CITY OF ALBUQUERQUE

Re: Legacy NAA Apartment, 6115
Request for Certificate of Occupancy
Transportation Development Final Inspection
Engineer's Stamp dated 11-18-16 (C18D064B)
Certification dated 12-26-17

LEGACY NAA APARTMENTS

A1.10
 SITE PLAN
 PRELIMINARY

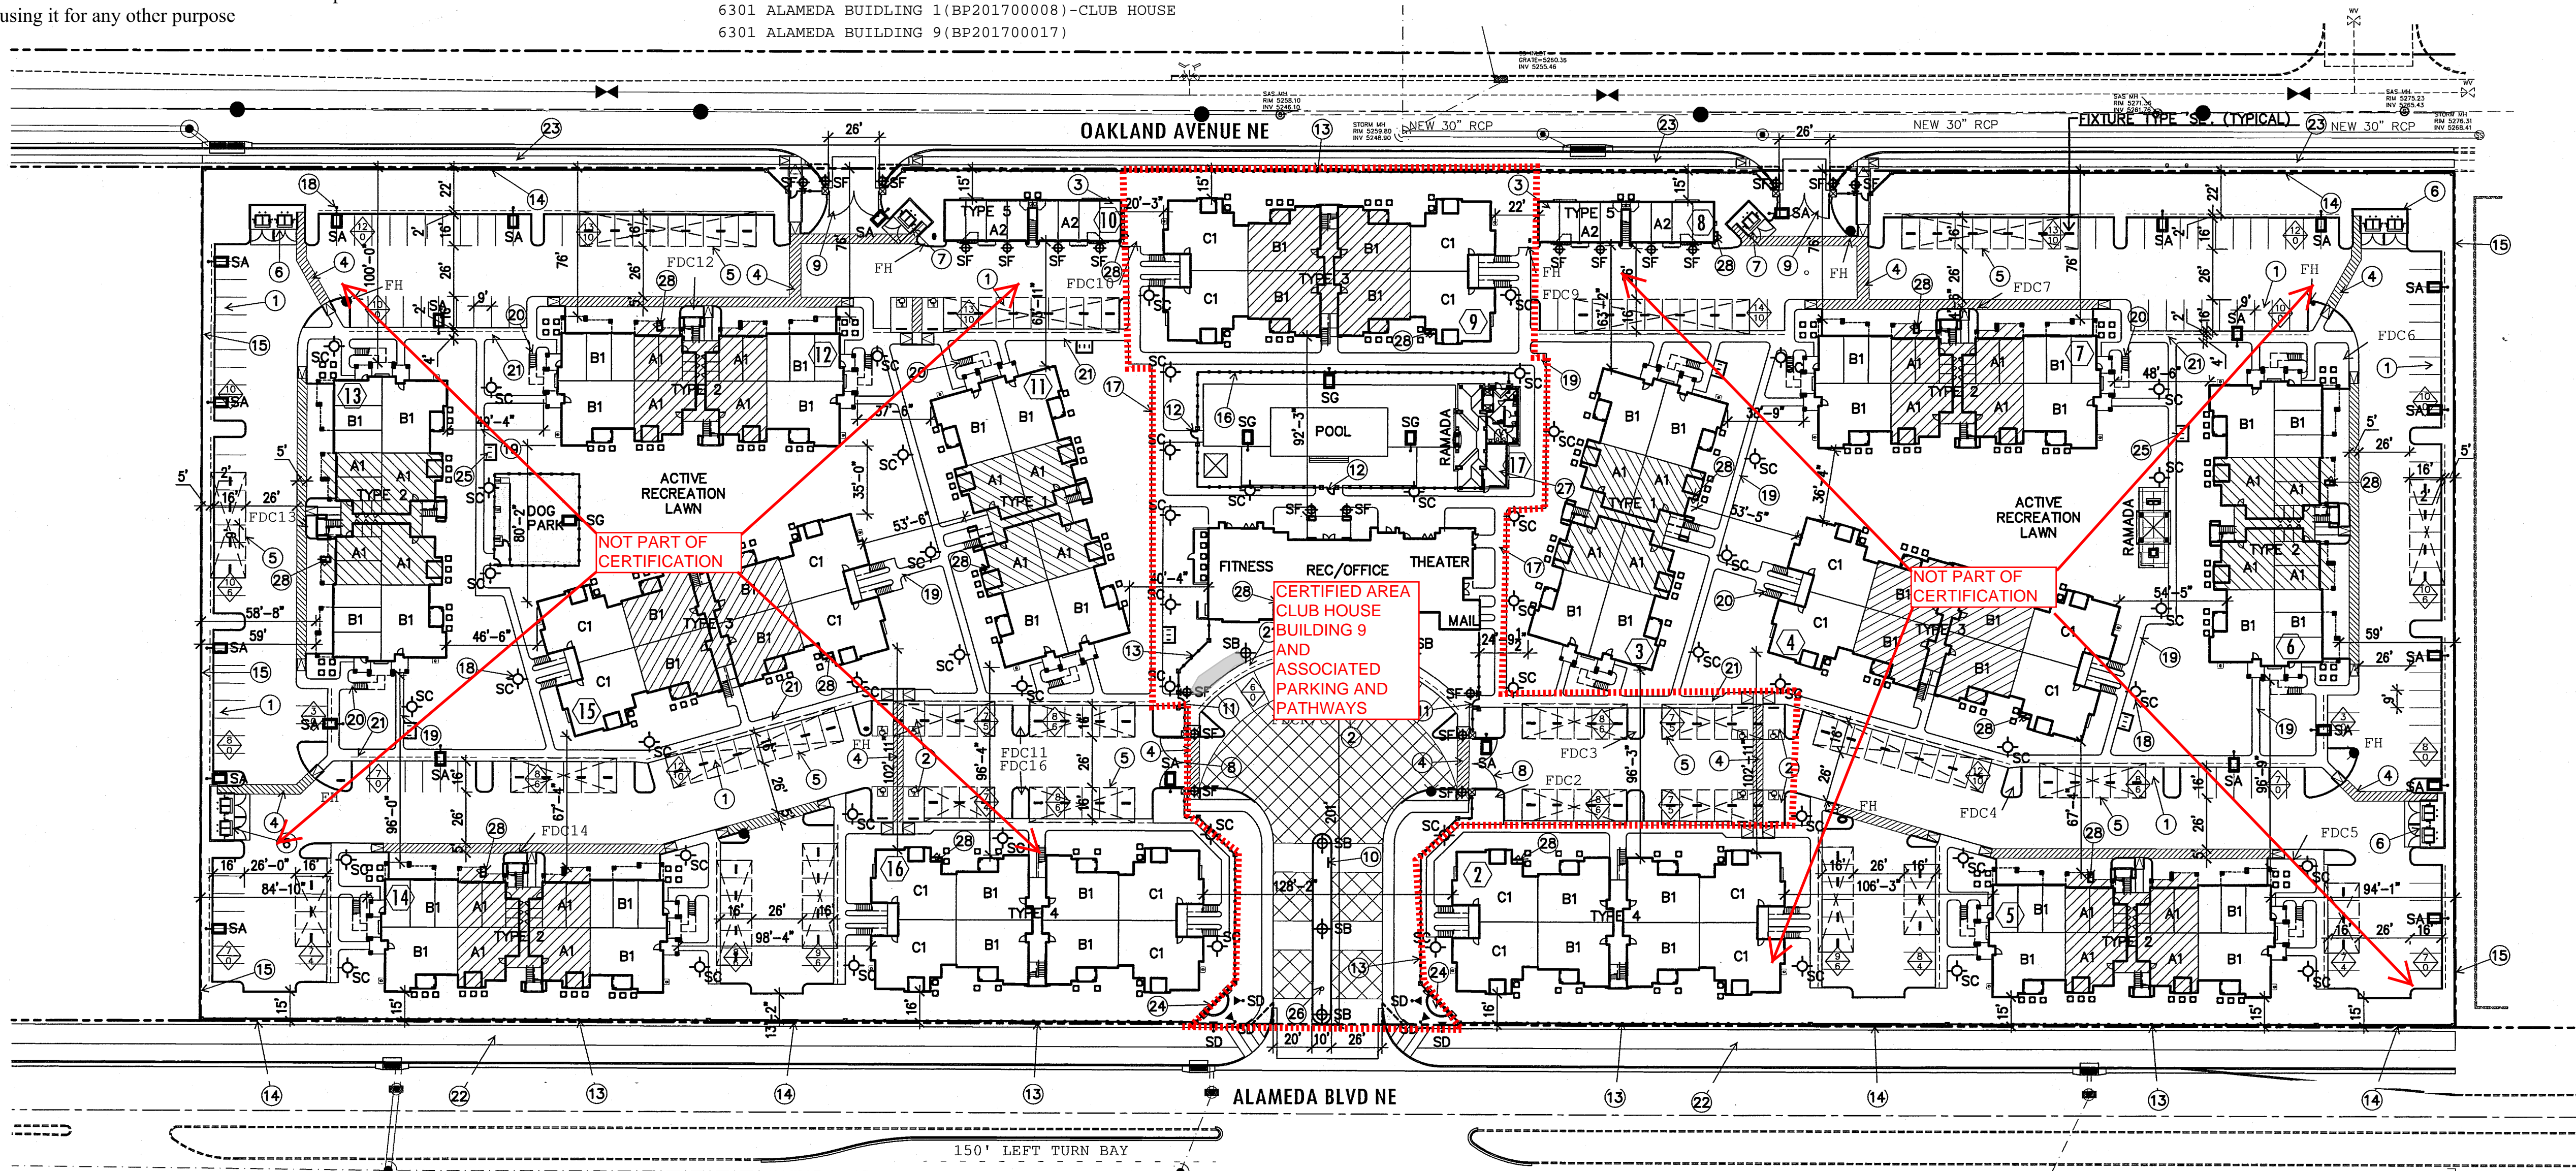
- Please make sure to provide ADA accessible parking sign and it must have the required language per 66-7-352.4C NMSA 1978 **"Violators Are Subject to a Fine and/or Towing."** Please call out detail and location of HC signs.
